ADDENDUM TO THE CONTRACT

GRUENING PARK LIFT STATION STAND-ALONE LIFT STATION Contract No. BE21-264

ADDENDUM NO.: THREE

DATE ADDENDUM ISSUED: June 30, 2021

GRUENING PARK LIFT STATION
RELOCATION
JUNEAU, ALASKA
LIFT STATION DETAILS

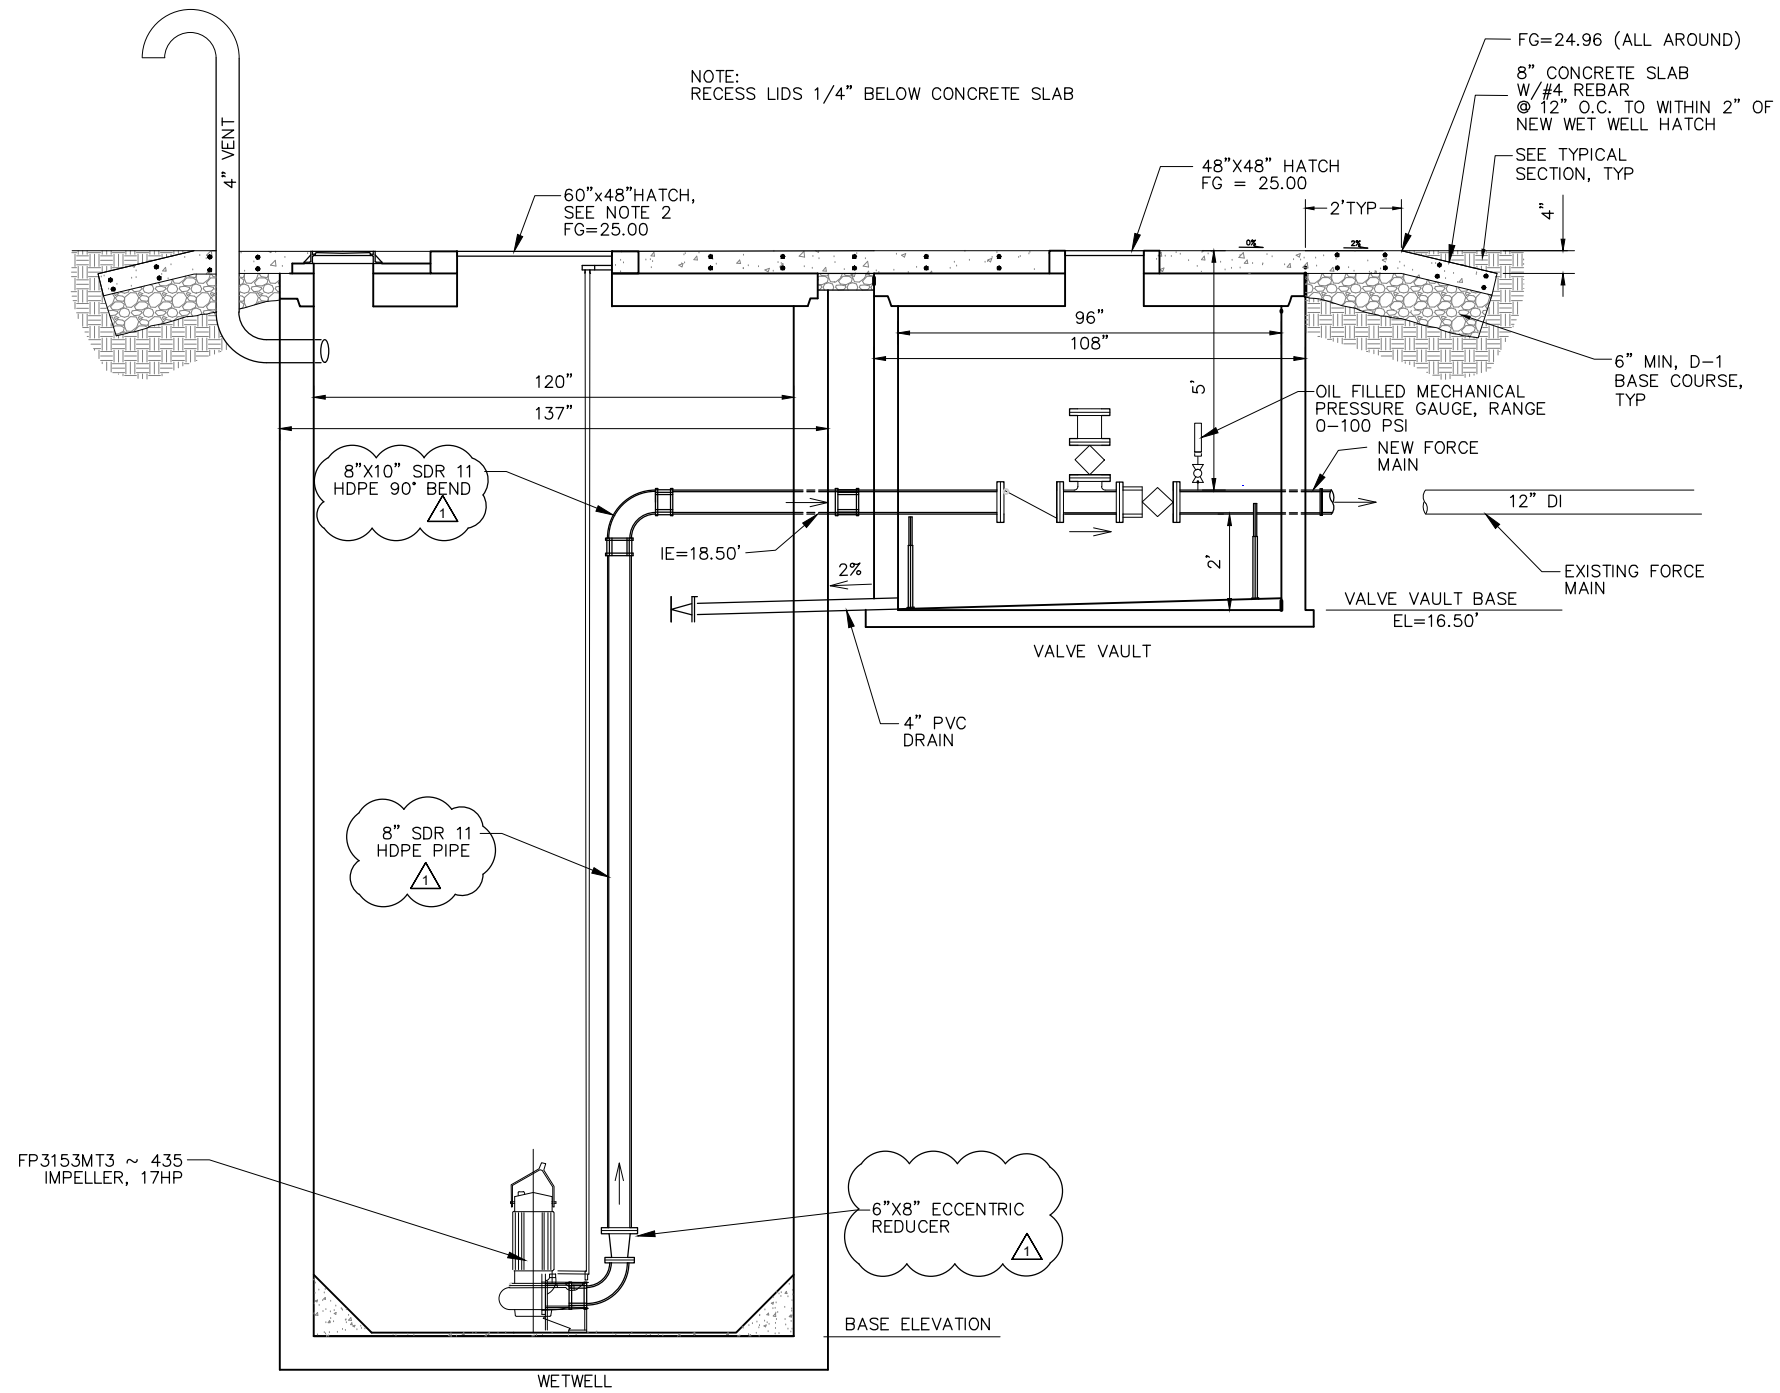
- Item No. 2 SHEET C5 – LIFT STATION DETAILS
Delete and replace SHEET C5 **with** the attached SHEET C5.
- Item No. 3 SHEET E3 – NEW ELECTRICAL SITE PLAN, Sheet Notes 1 and 3
Delete the last sentence **from** Sheet Note numbers 1 and 3, which read “Pay utility for their work.”
- Item No. 4 SHEET E10 – LIGHT POLE & HANDHOLE DETAILS, Detail 2 – Light Pole Base Detail
Change the light pole base dimension burial depth **from** 96” **to** 72”.

REV	DATE	DESCRIPTION	BY	CAN
1	6/28/21	PIPE SIZE CHANGES
